**WHITE LAKE TOWNSHIP  
ZONING BOARD OF APPEALS  
REGULAR VIRTURAL MEETING  
May 27, 2021 at 7:00 PM**

**TO:** Zoning Board of Appeals  
**FROM:** Justin Quagliata, Staff Planner  
**DATE:** June 24, 2021

# Proposed Addition for 9323 Gale Rd

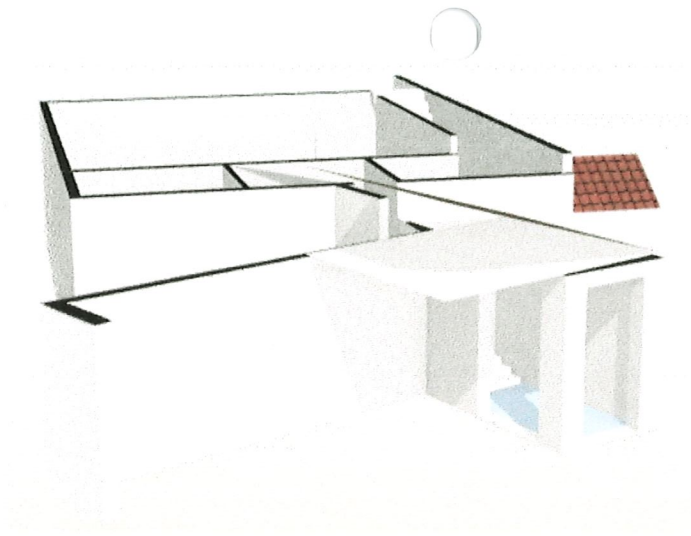
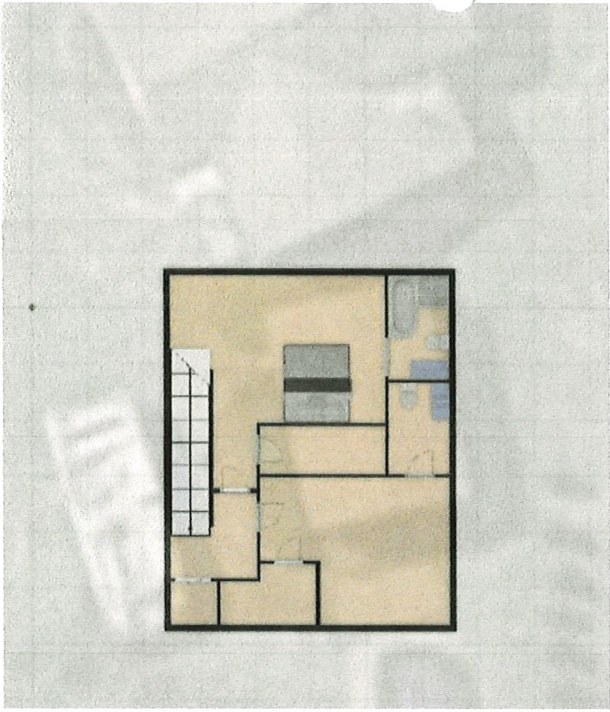
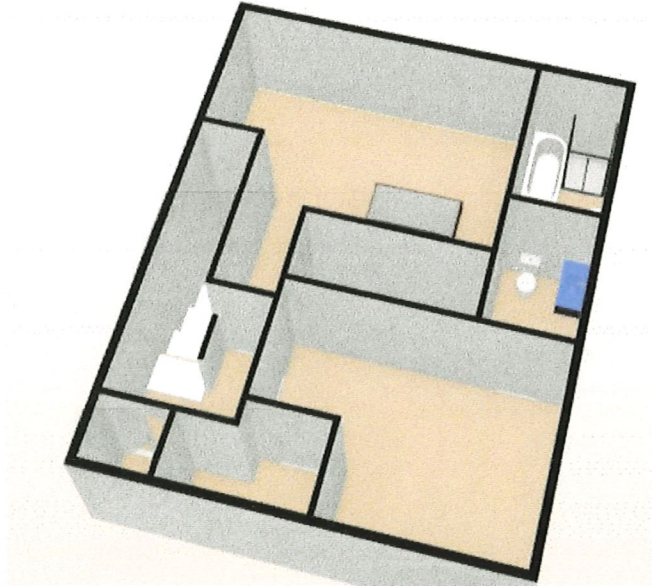
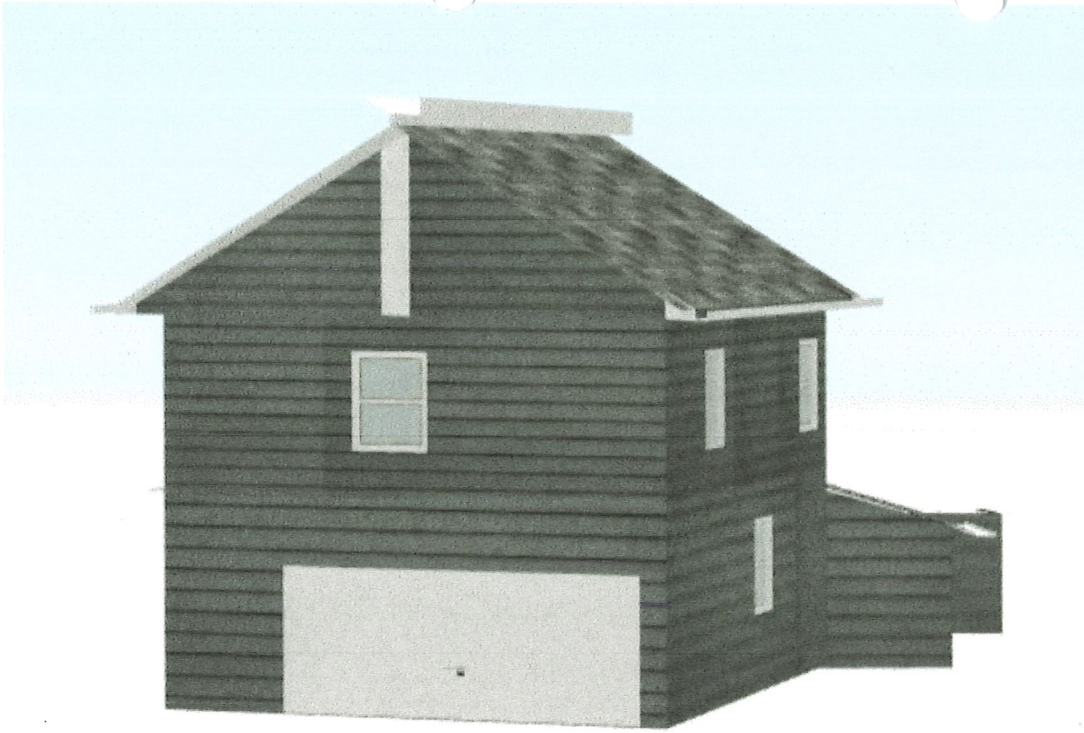
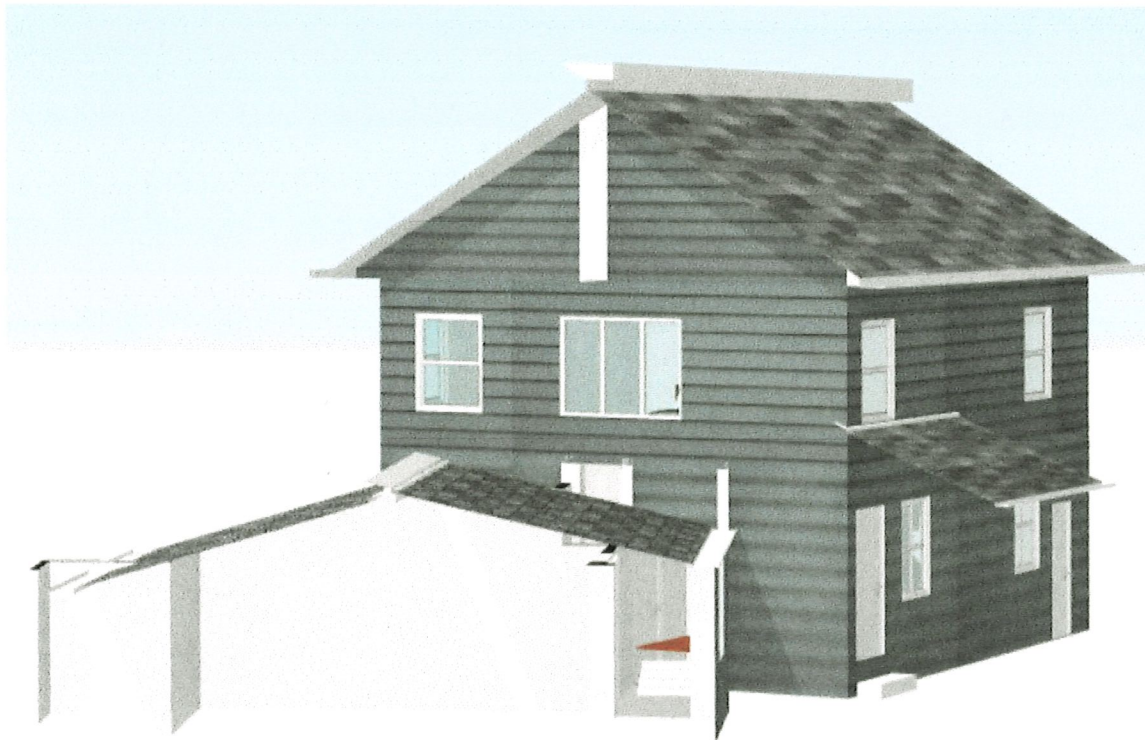
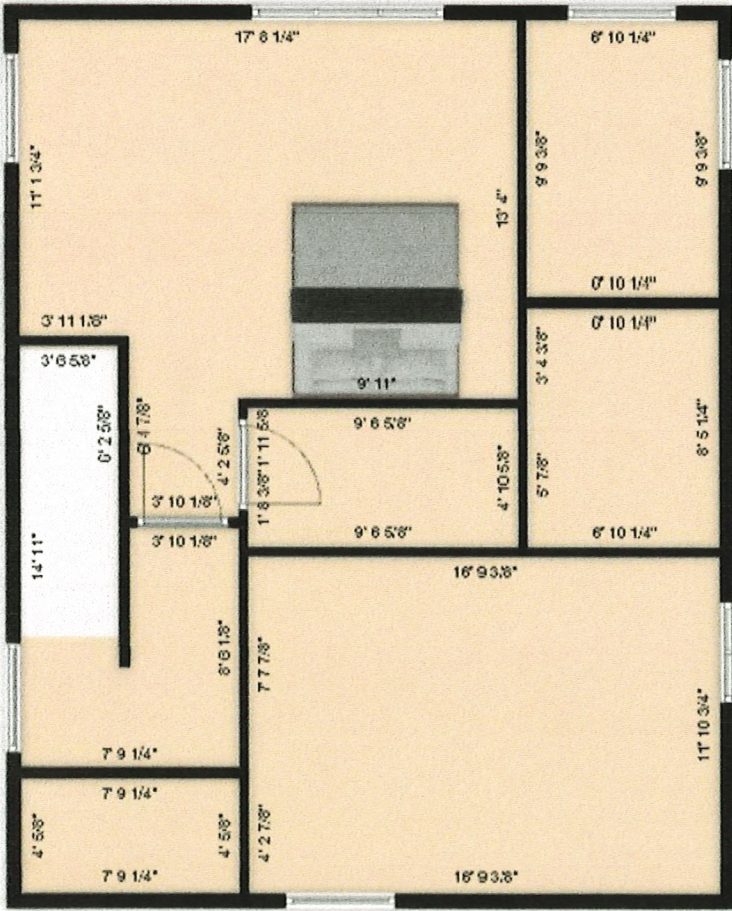
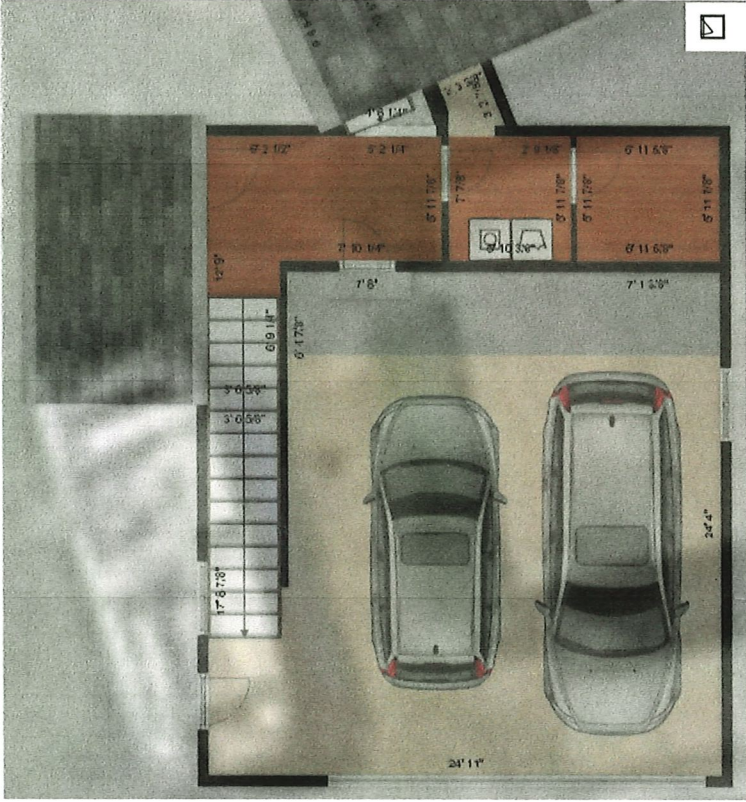
The proposed addition is 1,708 square feet in size. The first-floor would consist of a 676 square foot two-car garage and 200 square feet of living space, including a new laundry/utility room. The second floor would contain 832 square feet of living space, including two bedrooms and 1.5 bathrooms. The plans show a 5 foot by 5 foot (25 square feet) covered porch providing an exterior entrance to the addition; this secondary access would be independent from the house. The plans show another proposed porch on the east side of the house, which appears to serve as separate access to the existing house. Additionally, plans provided by the applicant note the current porch would tie-in to the addition. The porch does not have footings and cannot structurally accommodate the connection from the house to the addition.

Based on the submitted plans and scope of the project, staff believes the valuation of work is underestimated and would exceed \$80,000, therefore the requested variance for the value of improvements is inaccurate. For reference, the 2021 Building Valuation Data published by the International Code Council estimates cost of construction at \$130.58 per square foot for living areas (\$8.12 increase from 2020) and \$51.28 for garage area (\$2.98 increase from 2020). Based on the size of the addition and square foot construction costs from the International Code Council, an estimate for the value of the proposed improvement is \$169,424.

- The second-story addition shall not exceed 550 square feet in size.
- The second-story addition shall not include more than one (1) bedroom.
- The addition shall not exceed the maximum building height of the R1-D zoning district. Architectural plans, drawn to scale, shall be submitted at the time of reapplication for a building permit.

- Prior to issuance of a building permit, the Applicant shall submit a revised floor plan for the addition, which shall be subject to the approval of the Planning Department.

SHEET #  
**A.201**

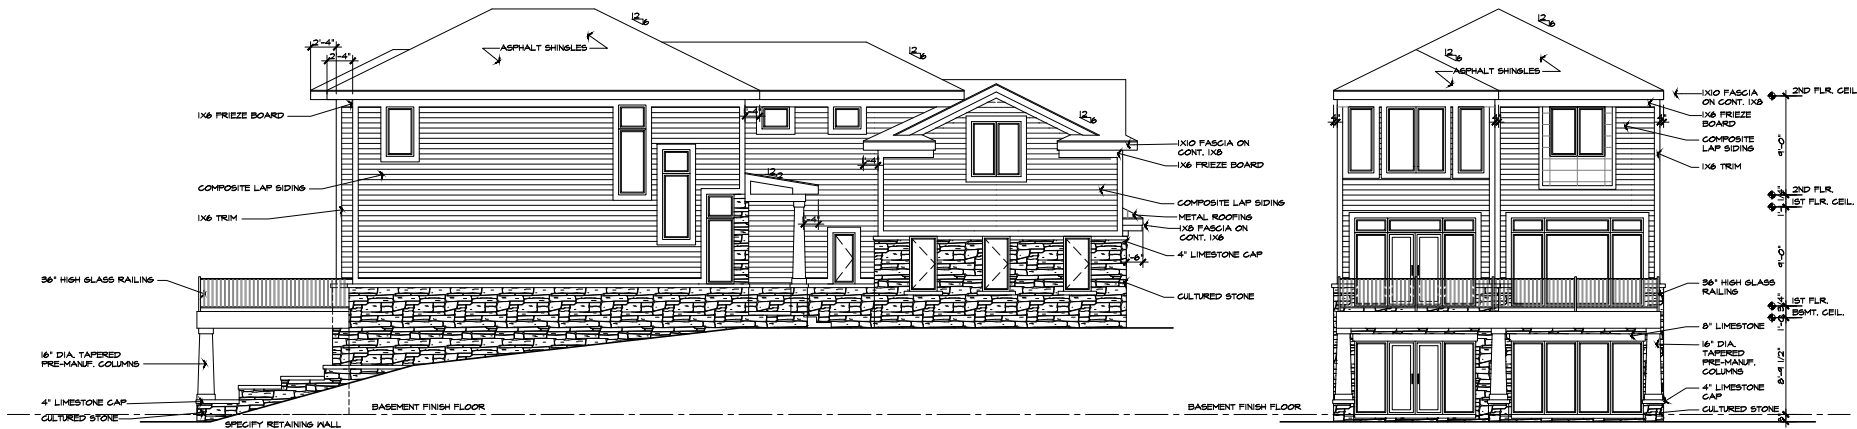
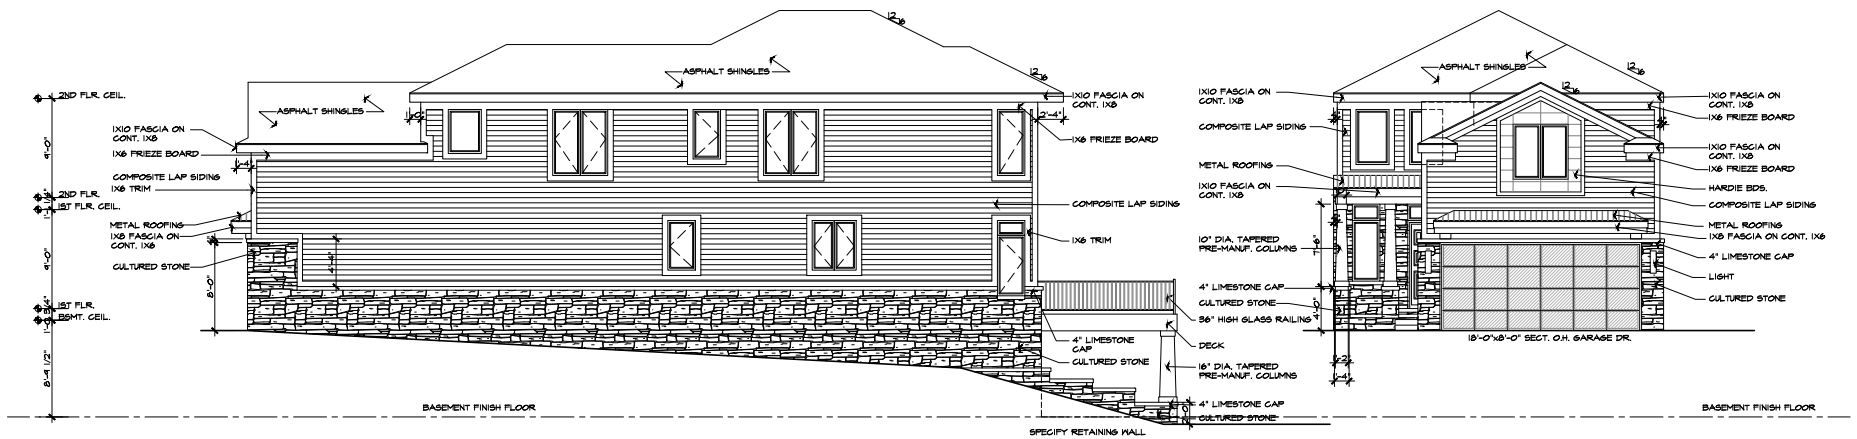
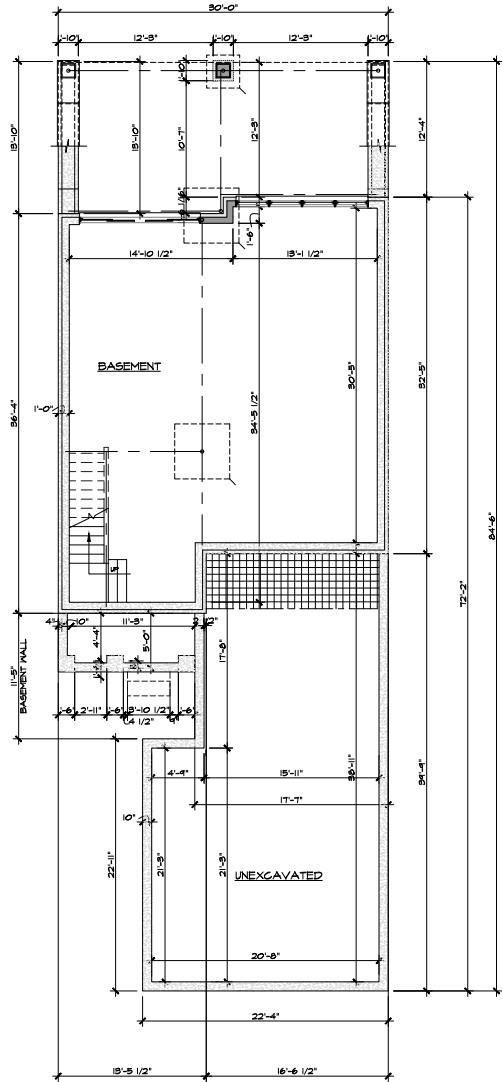
There were some changes to the floorplan from the prior project to the current request. A 578 square foot two-car garage is now shown as a 731 square foot three-car garage. On the second story, a dormer was added on the west side of the bonus room (44.58 square feet) and a 16.65 square foot balcony was removed. Overall, the plans note the second story increased 72 square feet.
